Control & Drive Systems Division
Fuji Electric FA Components & Systems Co., Ltd.

MICREX-SX Series SPH

Notice of Information Change on Label of Power Supply Module

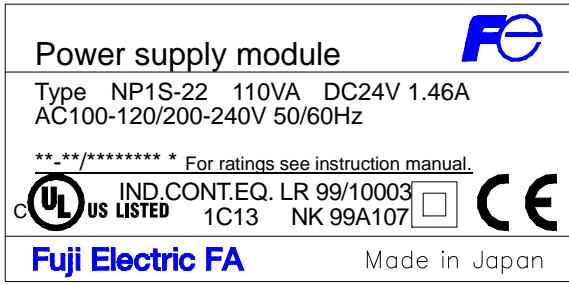
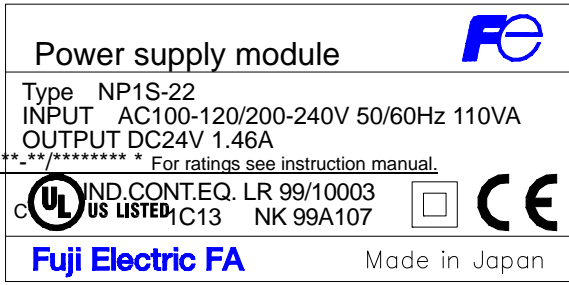
- (1) Applicable Types
MICREX-SX Power Supply Module
NP1S-22/NP1S-42/NP1S-91/NP1S-81
- (2) Contents of Change
Change in label information, addition of the words "INPUT" and "OUTPUT," and change in character layout.
- (3) Reasons for Change
Clarification of the input and output specifications
- (4) Details of Change

Before change	After change
 <p>Power supply module </p> <p>Type NP1S-22 110VA DC24V 1.46A AC100-120/200-240V 50/60Hz</p> <p>**_**/***** * For ratings see instruction manual.</p> <p> IND.CONT.EQ. LR 99/10003  </p> <p>Fuji Electric FA Made in Japan</p>	 <p>Power supply module </p> <p>Type NP1S-22 INPUT AC100-120/200-240V 50/60Hz 110VA OUTPUT DC24V 1.46A</p> <p>**_**/***** * For ratings see instruction manual.</p> <p> IND.CONT.EQ. LR 99/10003  </p> <p>Fuji Electric FA Made in Japan</p>
